# INTERNATIONAL URBAN-TRANSPORT-ARCHITECTURAL TWO-PHASE RESTRICTED PROJECT COMPETITION FOR THE

## "Brno New Main Train Station"

## **EXPLANATION OF COMPETITION CONDITIONS NO 29**

Annex 1 – Current photos of the model of the surrounding area

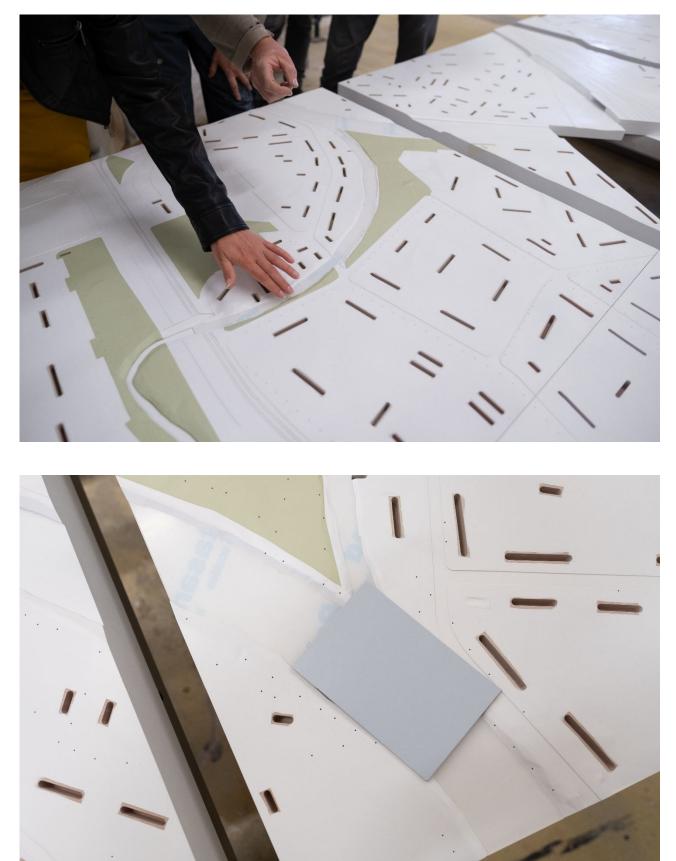
Is it possible to provide recent photographs of the physical model of surroundings? Have the same colours been used for final treatment, which were recommended for the insertion model? What type of tree staffing has been or will be used for the model (material, colour)?

Current photographs, which show the colour and staffing of trees, are provided in Annex 1 to this Explanation and also in the Explanation of the Competition Conditions No 27. The model uses the colours recommended in Annex 2 to the Call for Submission of Proposals in the 2nd phase of the Competition.
